Ref. 40813

**RE: DA/11/2017: Proposed Multistorey Commercial & Residential Flat Building –  
Brooks Parade, Belmont**

Reference is made to Council's correspondence to Monteath & Powys P/L of 17<sup>th</sup> March 2020, itemising items to be addressed in support of the above development application.

**BASEMENT 1/GROUND FLOOR STORMWATER PLAN**  
1:200

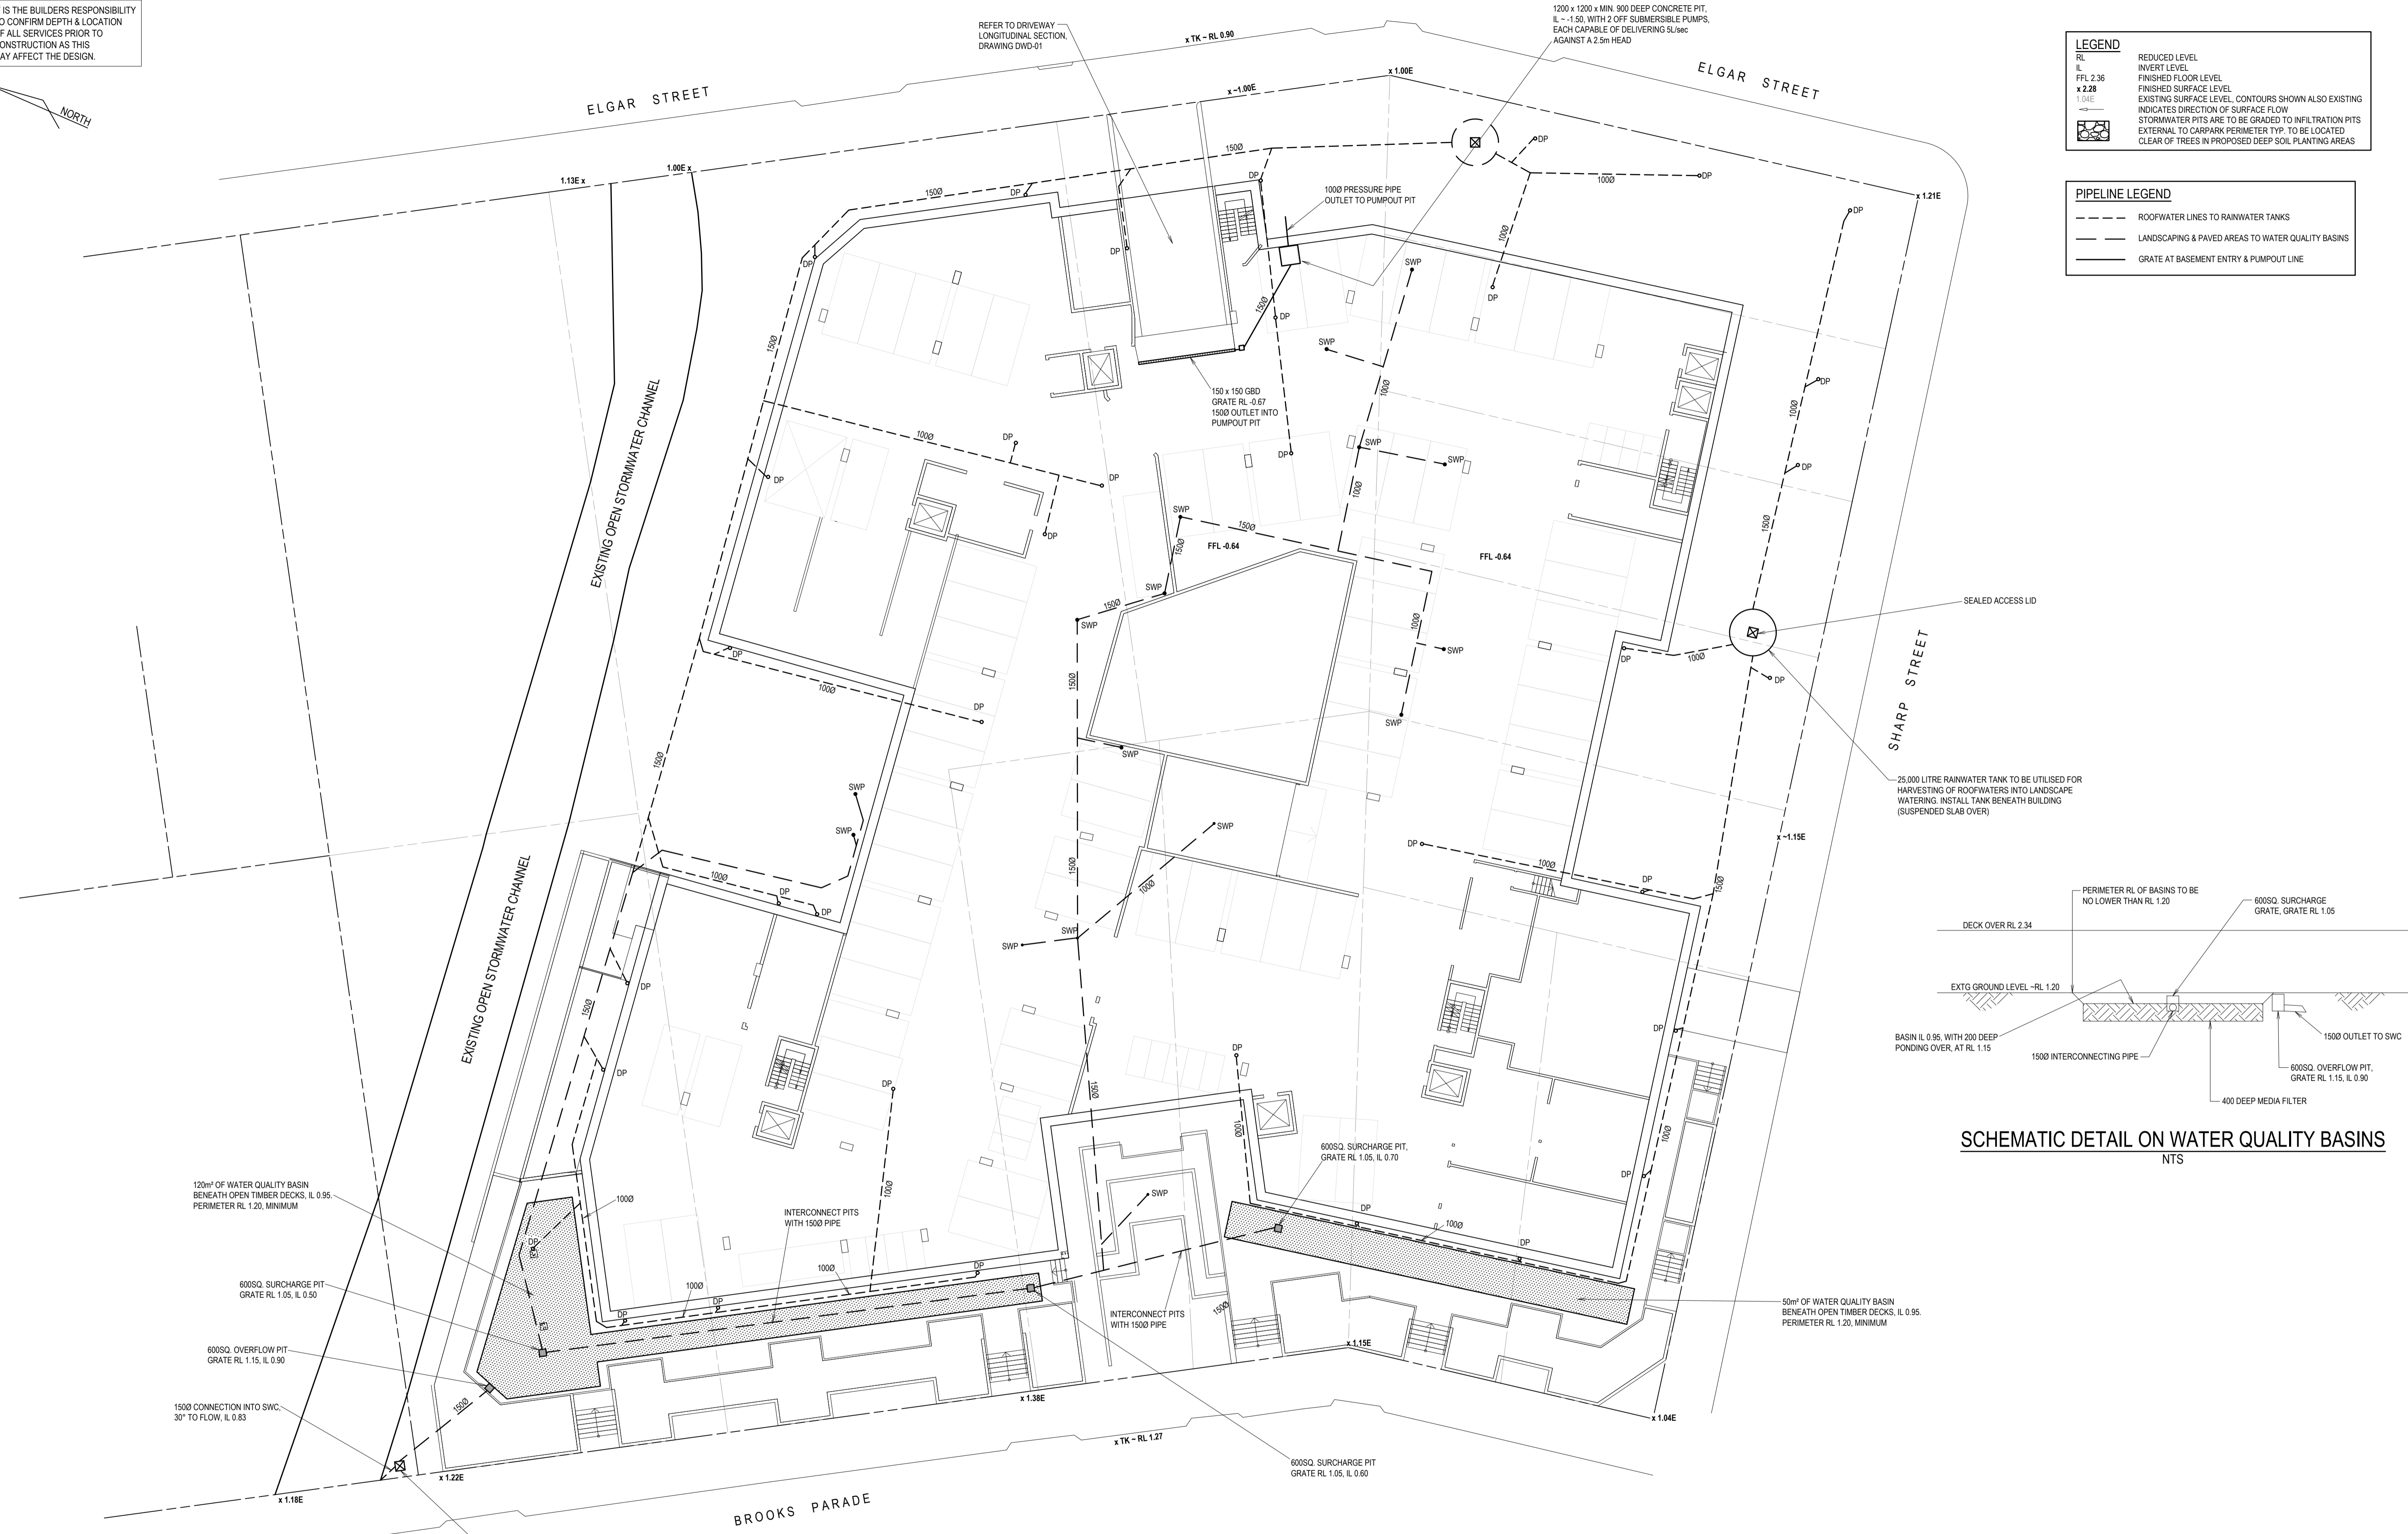
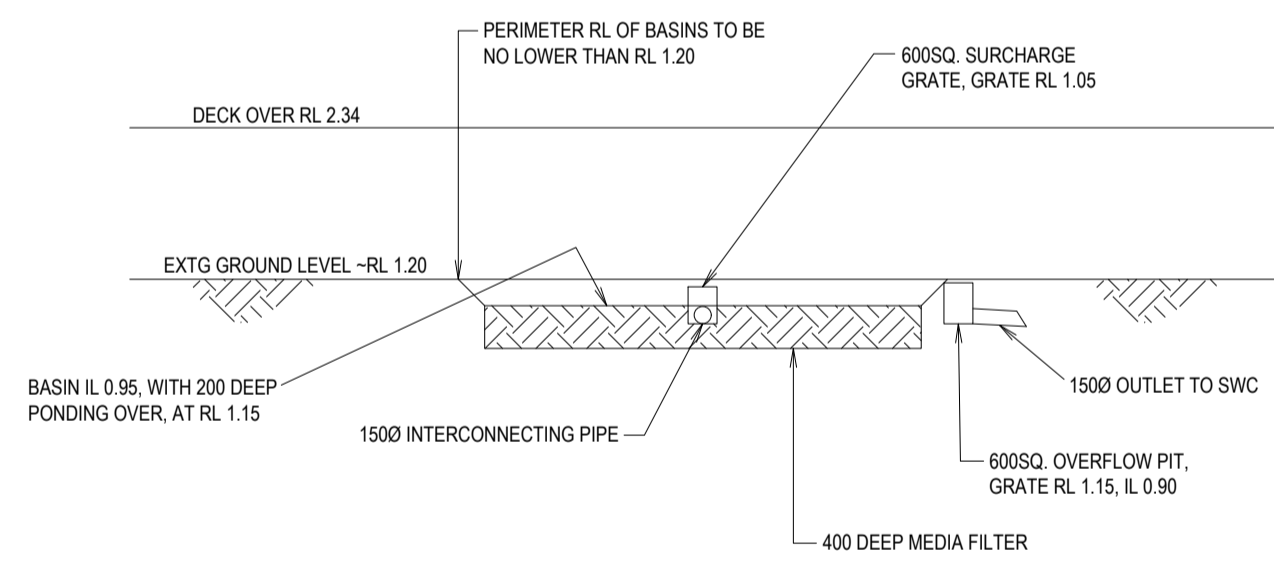
- 7.5 Infiltration was proposed to drain all landscaped and paved areas to the development, whilst all roof areas are discharged to rainwater tanks for reuse. The requirement now to address water quality for the landscaped and paved areas is proposed to be addressed with construction of filter media basins. Inclusion of these with an additional infiltration depth would result in the base levels being too close to the groundwater levels, so for this reason we are no longer proposed infiltration basins but water quality basins overflowing to a formal stormwater system connected to Brooks Parade stormwater system, as now detailed on our amended drawing 40813-SWD 01F. Attached to this report are the MUSIC calculations supporting this proposal.

- 7.6 With reference to comment 7d) The stormwater concept has been misunderstood. The design is for all paved and landscaped areas to go now to the water quality basins (previously to the proposed infiltration basins), all roof water to the rainwater tanks for reuse. The only water going to the basement pumpout pit is from 40m<sup>2</sup> of exposed ramp area. For the amended stormwater drawings we have now amended our line types to hopefully indicate this more clearly.
